Solano County Airport Land Use Commission

To: Solano County Airport Land Use Commission
From: Jim Leland, Principal Planner
Subject: **ITEM 9A: ALUC-15-02:** (Verizon) **Action Item:** Conduct a Public Hearing to consider the consistency of ALUC-2015-12 (Verizon) with the Travis AFB Land Use Compatibility Plans. Sponsor: County of Solano
Date: Meeting of July 09, 2015

AREA MAP

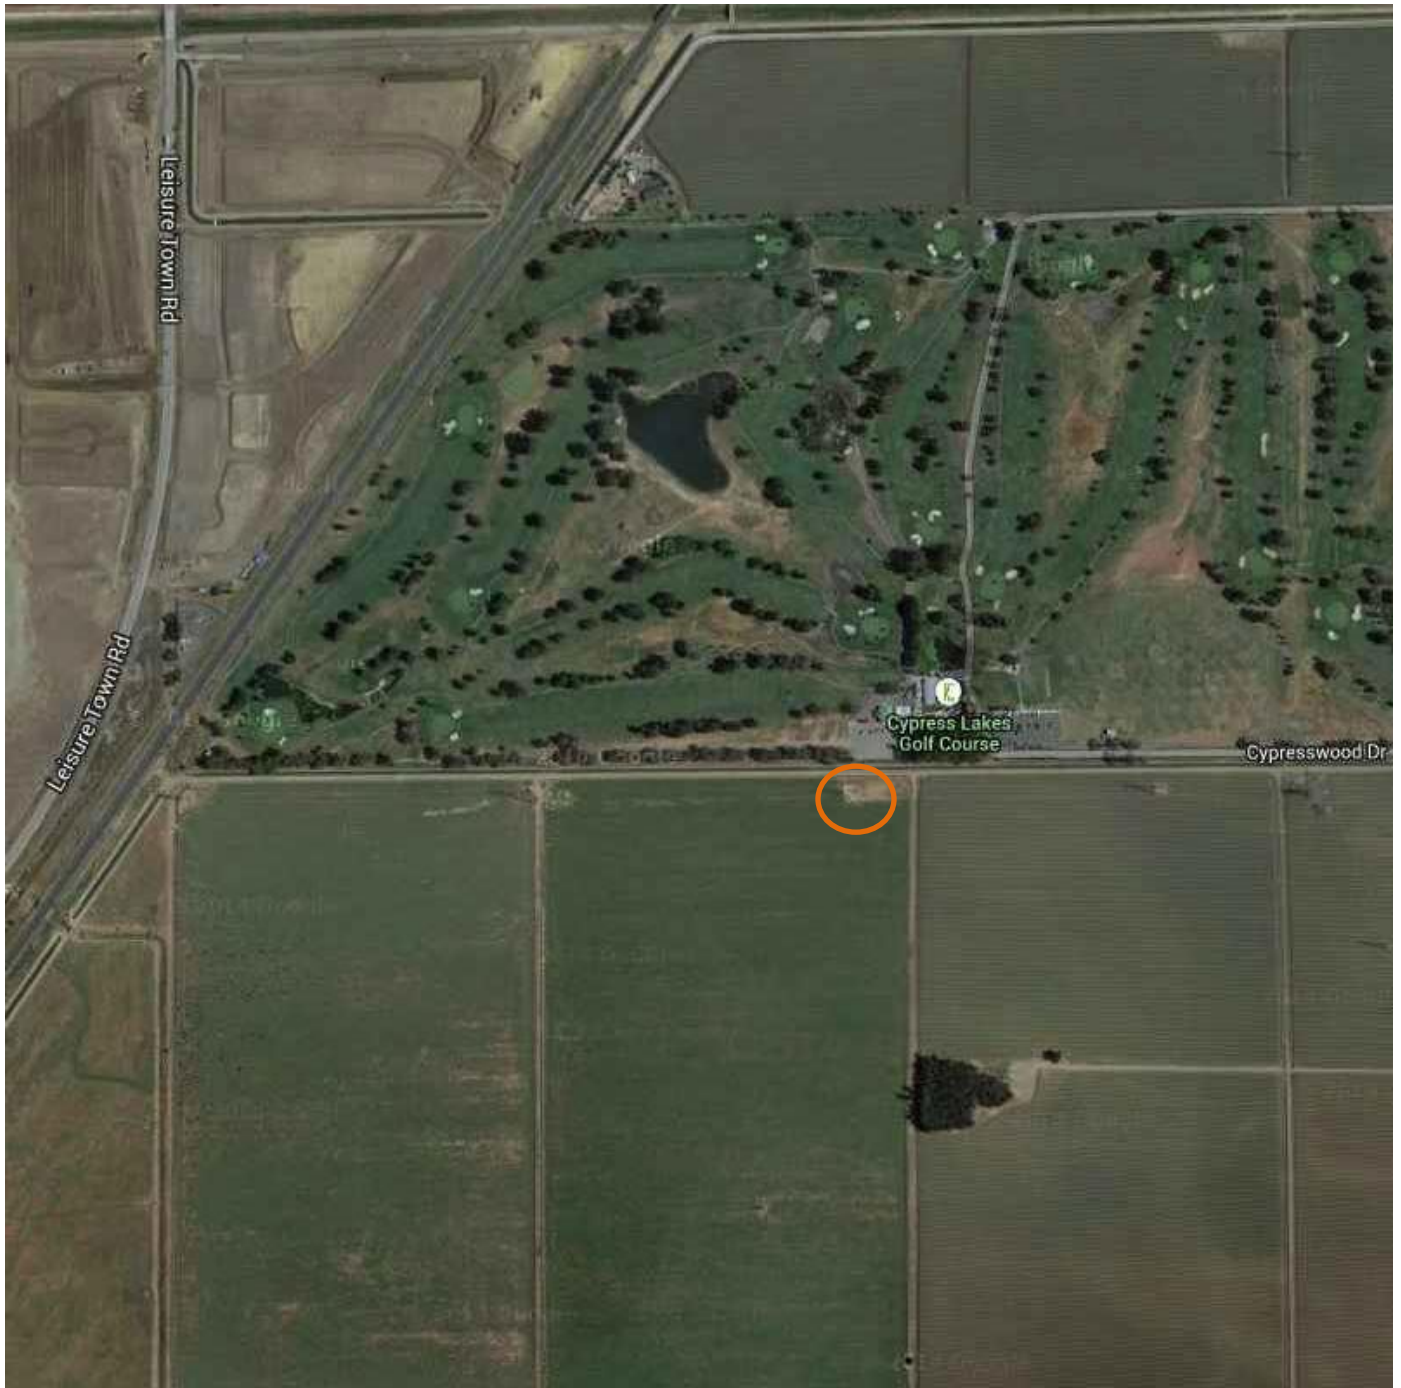
The County of Solano is in the process of reviewing a use permit to permit Verizon Wireless to increase the height of an existing PG&E tower to accommodate 6 wireless communication antennas (The existing tower is located on the south side of Cypresswood Drive, between Meridian Road and the Southern Pacific Railroad ROW (See Area Map below).

Portion of FIGURE 2C

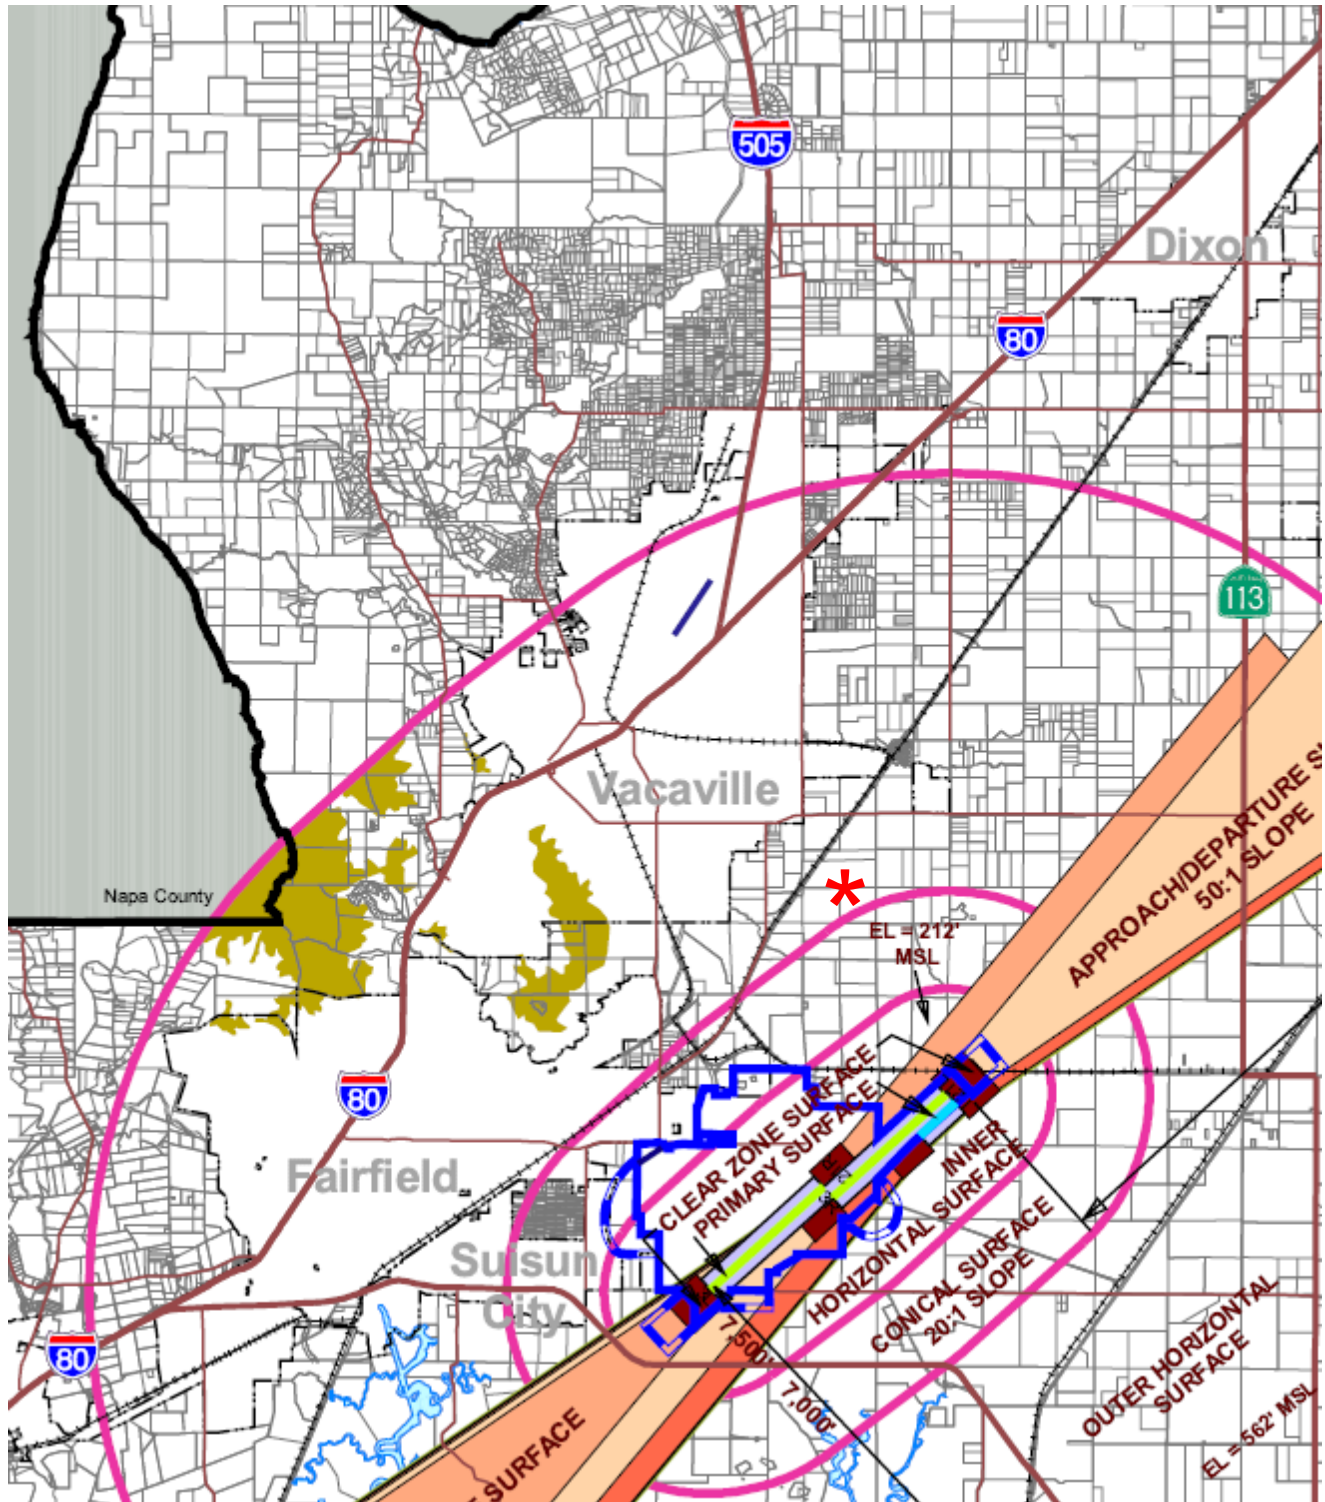
The Airspace Protection Zones Map, Figure 2C, indicates that the height of the Part 77 imaginary airspace surface is 562 feet MSL, or 500 feet above the airfield elevation. The proposed project consists of one PG&E tower being raised to 143 feet in height above ground elevation. The total height of the tower is therefore less than the Part 77 surface height of 500 feet above ground level.

According to Figure 2C, Airspace Protection Zones, the proposed project does not lie within any instrument approach procedure route. Therefore, there are no further height restrictions pursuant to this requirement.
